# Author's response to Referee #1

April 24, 2019

Figure 1: Wind angles and true air speed (TAS) of the 5-hole probe for the evaluated vortex measurements. Grey dashed line shows the calibration limit of  $-20$  to  $20$  degrees. Overstepped angles are interpolated.

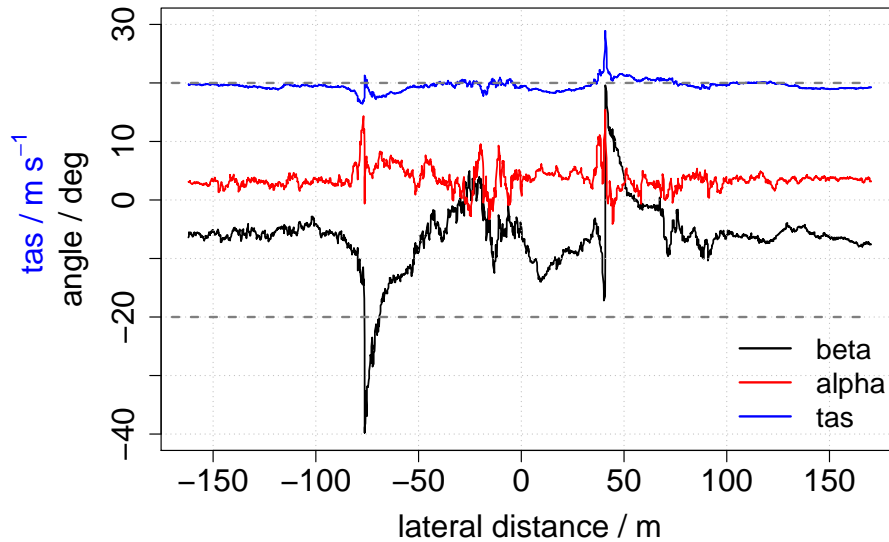
- *It is known that the estimation of the UAV attitude is a major source of error for the wind calculation. It is also known that navigation systems are less precise in dynamic flight manoeuvres. I would therefore at least expect that attitude angles as well as airspeed and flow angles during the flight through the vortex are shown. The authors raise the issues themselves in the discussion, but I think it is necessary to include a proper analysis of this in the manuscript, including an estimation of uncertainty of the wind vector and thus the circulation.*

The attitude angles of the UAS will be shown in an extra evaluation (e.g. subsection) also including an error estimation of the wind velocity and the measured circulation. See also Fig. 1 and Fig. 2 for a first look.

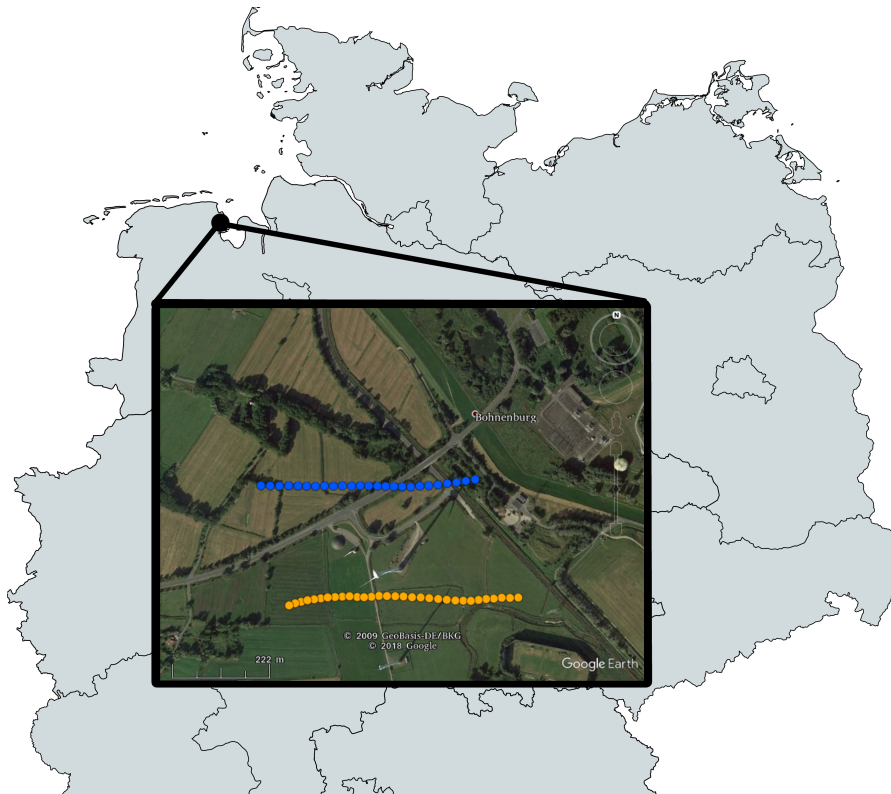
*Fig.3: I think a more schematic background (not Google Earth) with a better scale and legend would help* Google Earth map/image was replaced with a schematic map of Germany (cf. Fig. 3).

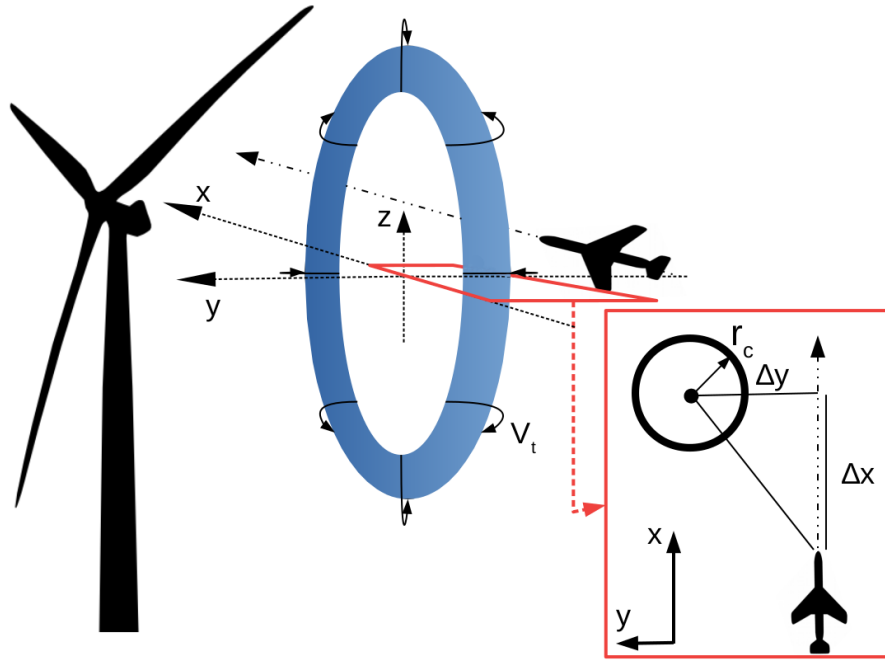
*Fig.7: Nice figure, but watch out for which lines cross in front of or behind other lines to get the 3D visualization right. I think the red rectangle encloses the blue vortex, right? And "distance" should probably get a variable name or could even be left out.*

First of all, thank you for the compliments. The line issue has been addressed. They should now support the viewer's perspective. 'Distance' has been removed. An updated figure will be found in the new manuscript (cf. Fig. 4).
